PLAN COMMISSION MEETING

Re: Sandy Bay Highlands Subdivision No. 3
Final Plat Comments

MULTI-FAMILY RESIDENTIAL DEVELOPMENT
3000 FOREST AVENUE
CITY OF TWO RIVERS, WISCONSIN

SITE PLAN

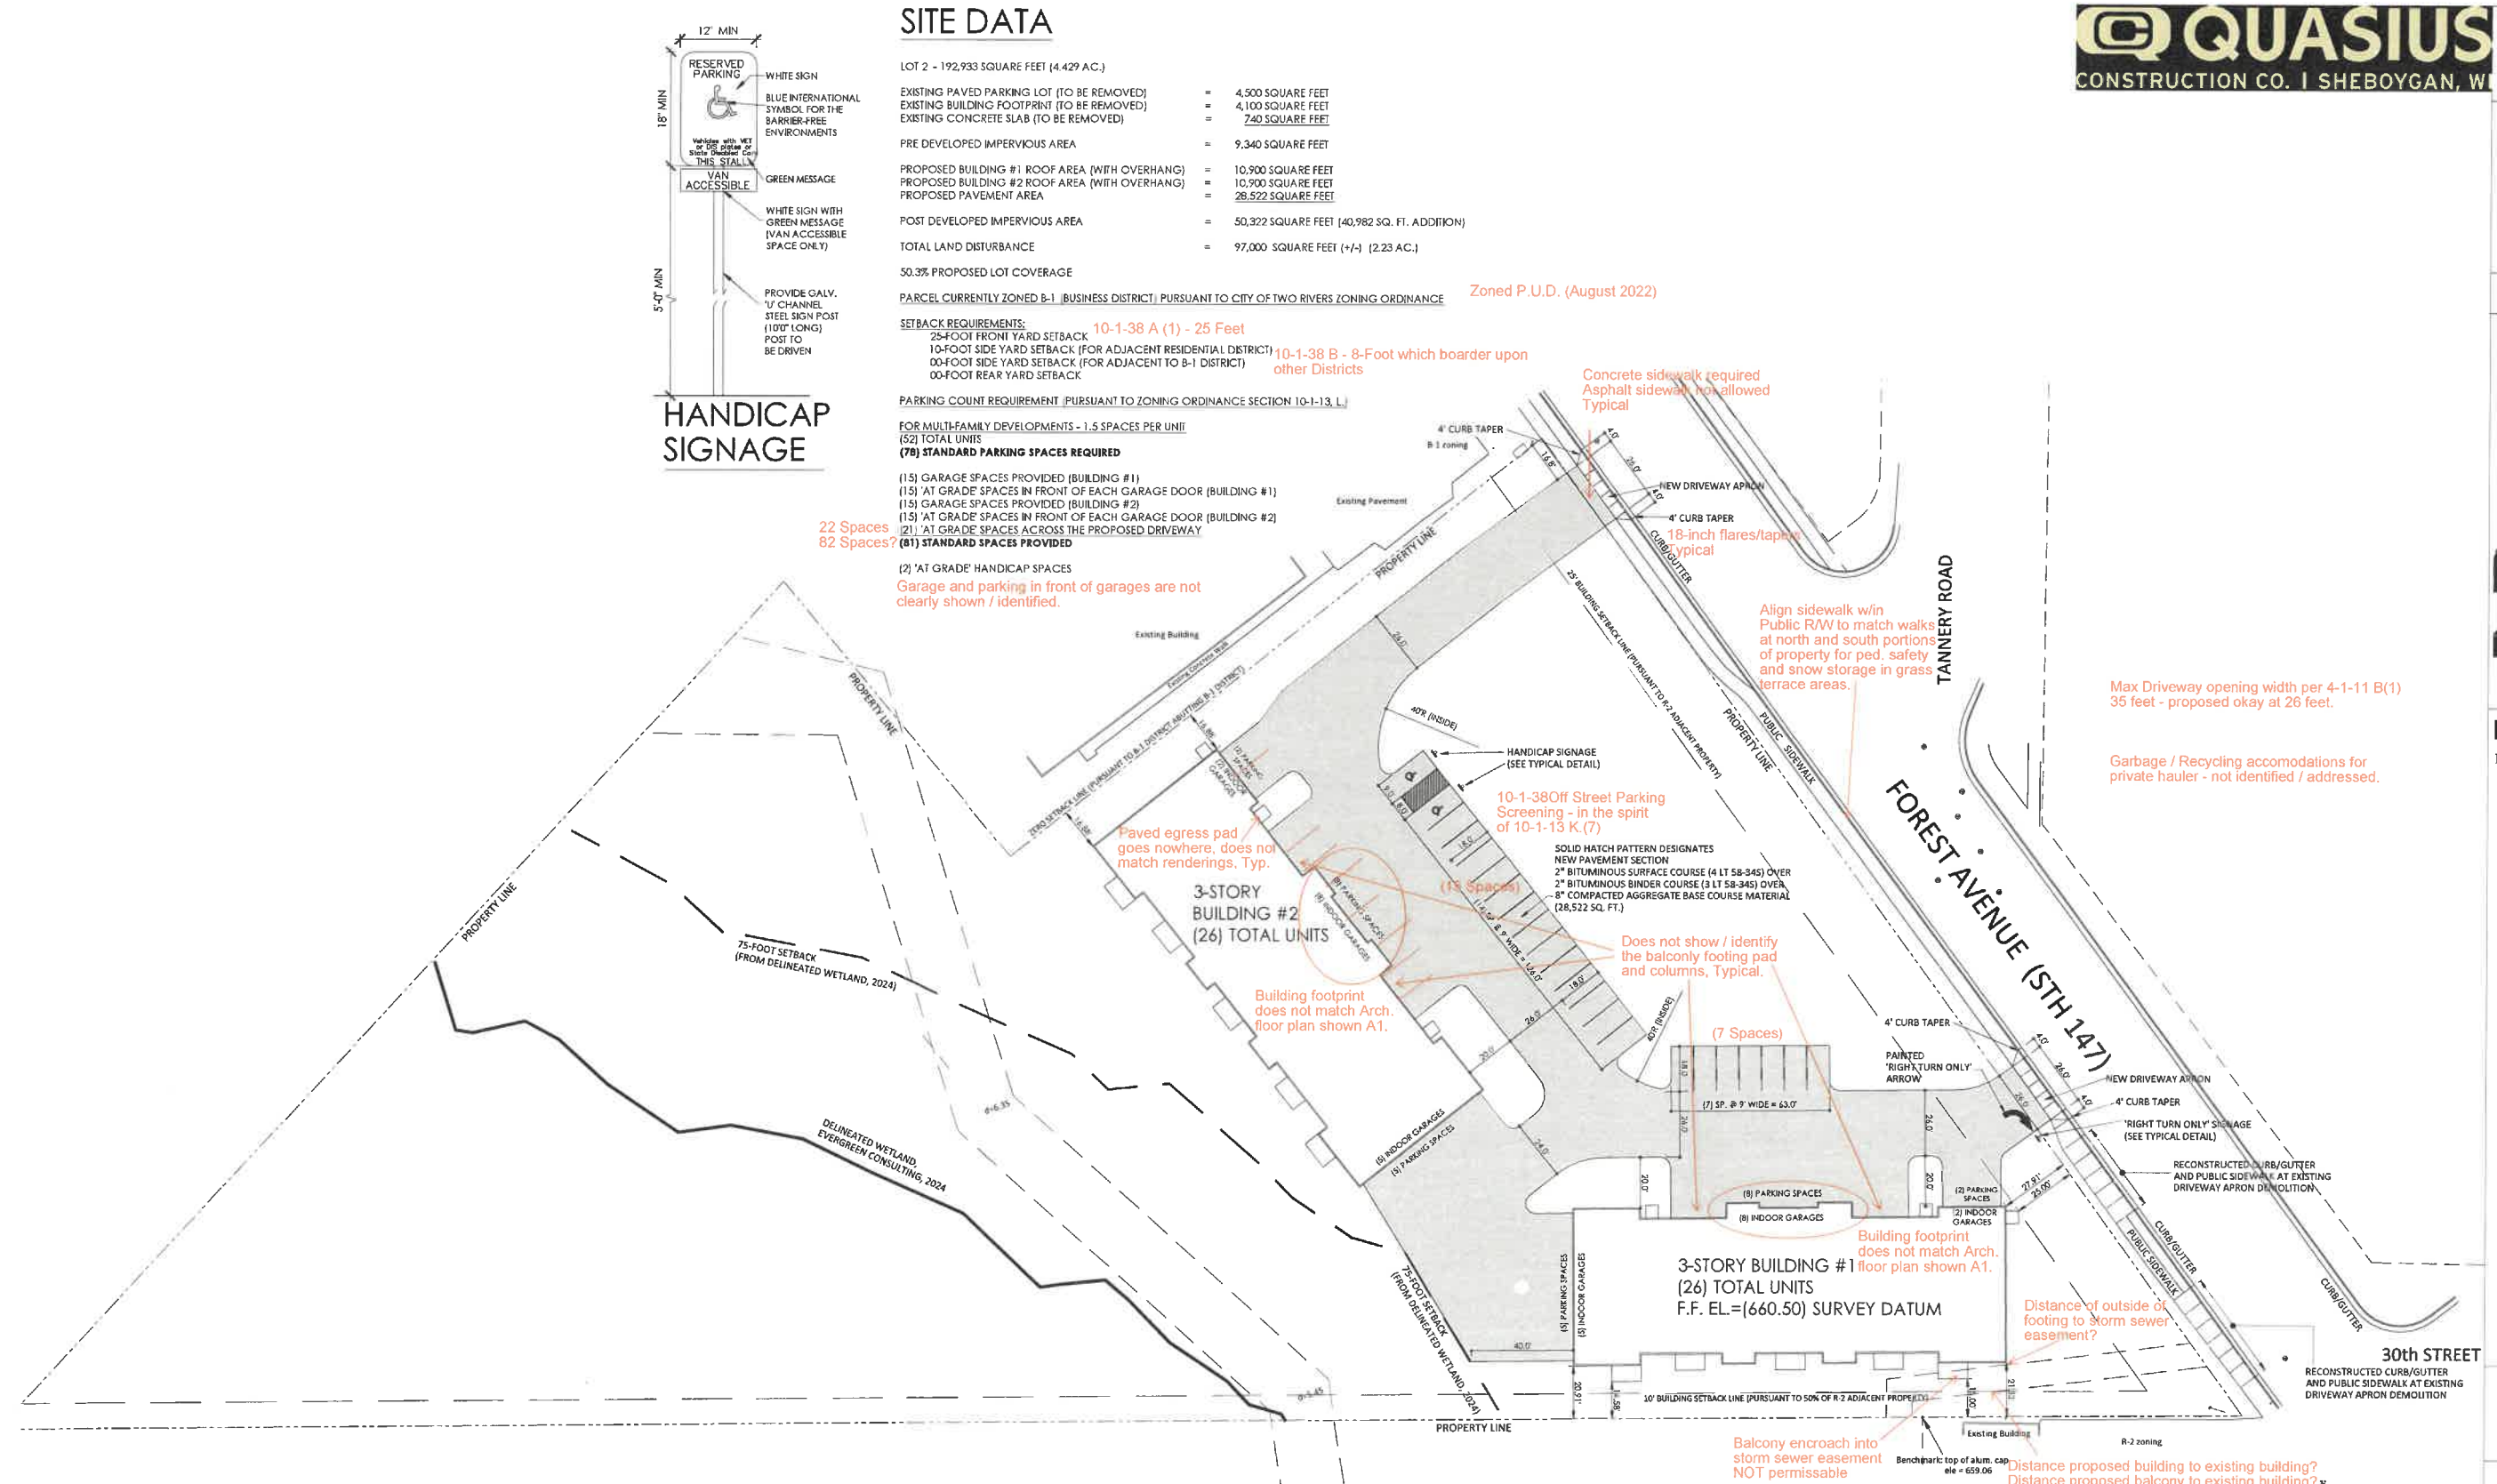
PARCEL CURRENTLY ZONED B-1 BUSINESS DISTRICT PURSUANT TO CITY OF TWO RIVERS ZONING ORDINANCE **Zoned P.U.D. (August 2022)**

SETBACK REQUIREMENTS:
 25-FOOT FRONT YARD SETBACK **10-1-38 A (1) - 25 Feet**
 10-FOOT SIDE YARD SETBACK (FOR ADJACENT RESIDENTIAL DISTRICT) **10-1-38 B - 8-Foot which boarder upon other Districts**
 00-FOOT SIDE YARD SETBACK (FOR ADJACENT TO B-1 DISTRICT)
 00-FOOT REAR YARD SETBACK

(2) 'AT GRADE' HANDICAP SPACES
 Garage and parking in front of garages are not clearly shown / identified.

22 Spaces
 82 Spaces?

SITE GRADING AND EROSION CONTROL PLAN

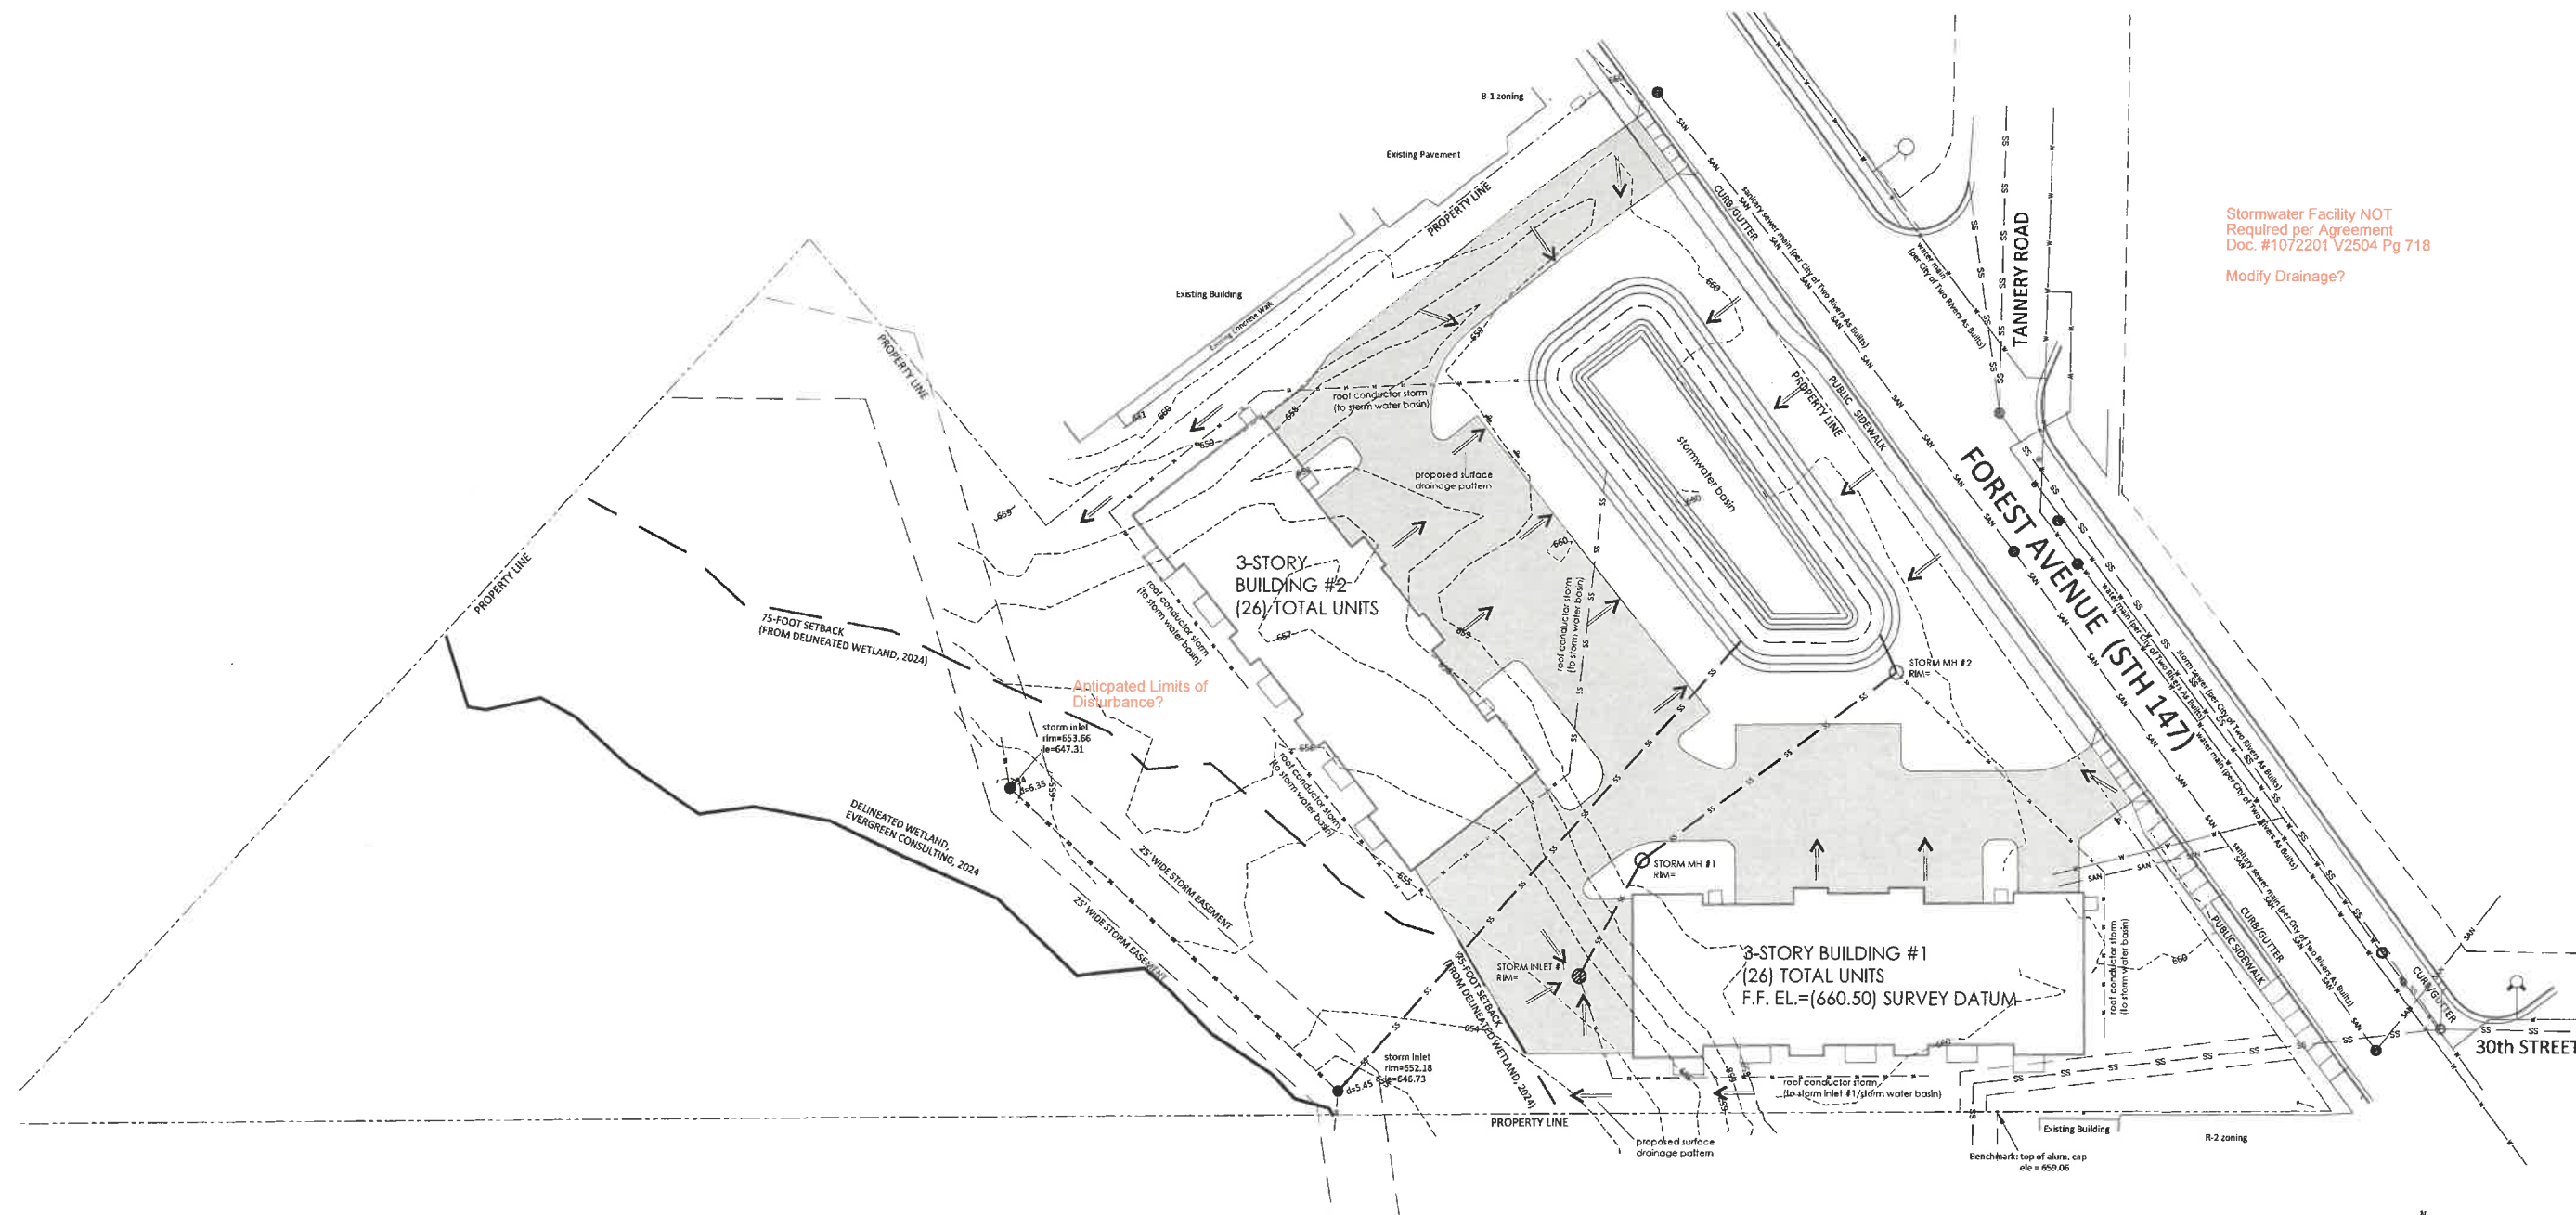
Stormwater Facility NOT
Required per Agreement
Doc. #1072201 V2504 Pg 718

SITE LANDSCAPE PLAN
 1"=30'

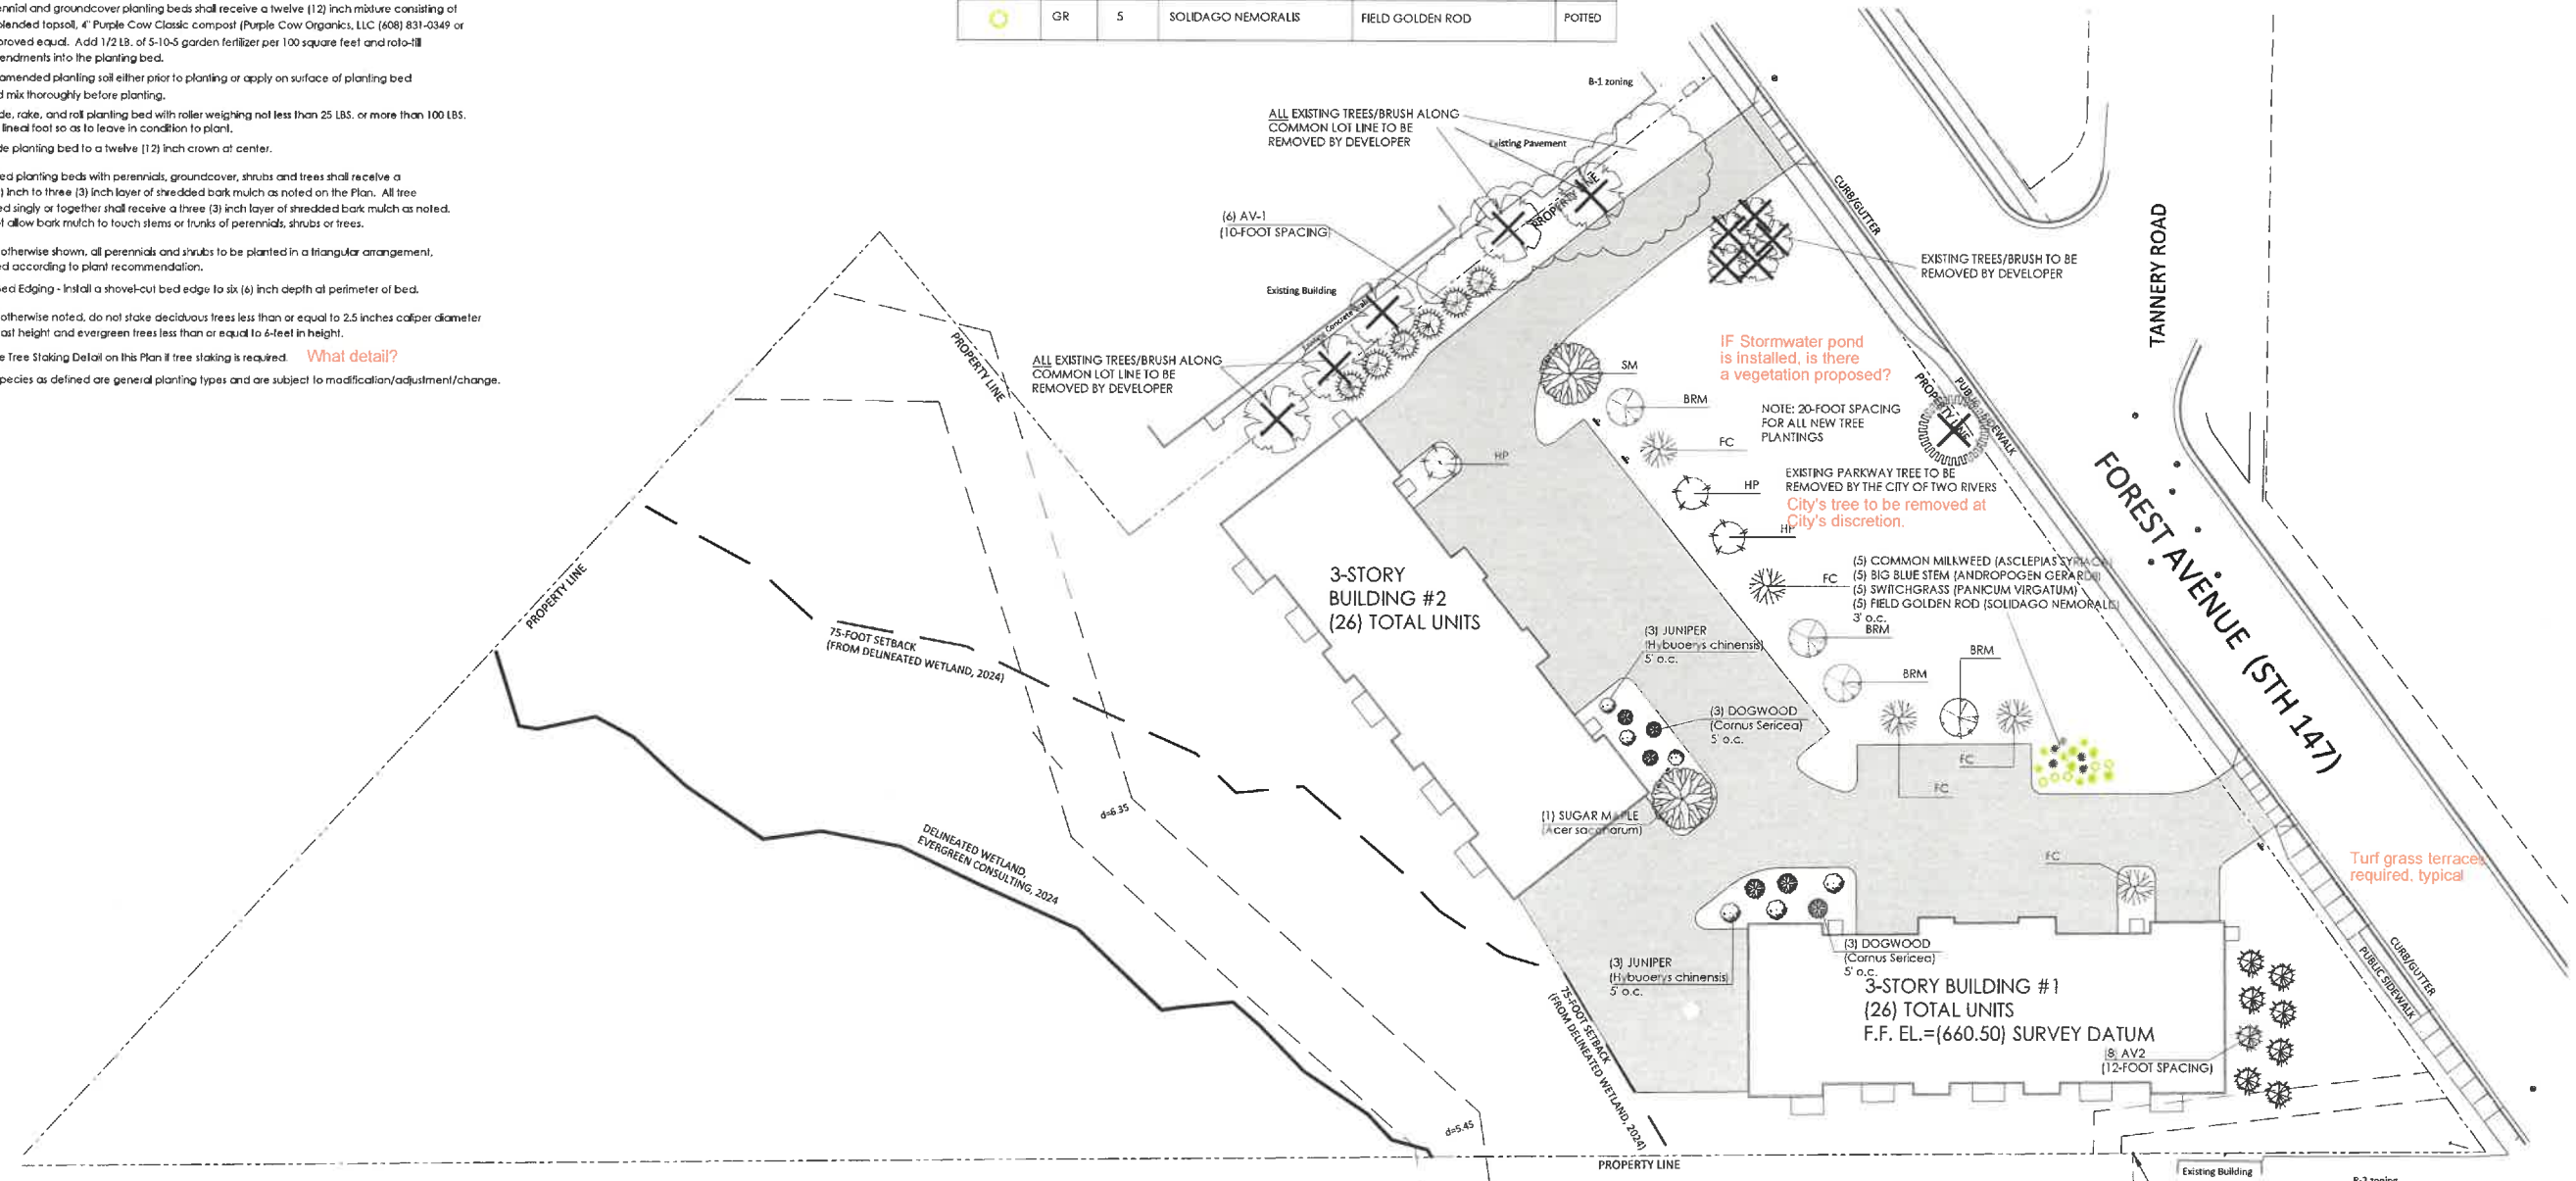
- All work shall be in conformance with all applicable local codes and ordinances.
- All areas disturbed by grading or site construction shall be fine graded, planted or seeded. **Seeded with what?** See notes for specified seed mixes and installation procedures.

- All turf grass areas shall receive a blended topsoil mix to a depth of six (6) inches. Contractor shall provide positive drainage away from all buildings for a minimum of ten (10) feet. **Turf areas not identified**

- See the Tree Staking Detail on this Plan if tree staking is required. **What detail?**
- Plant species as defined are general planting types and are subject to modification/adjustment/change.

Why is there a 2nd landscaping plan after Sheet C7?
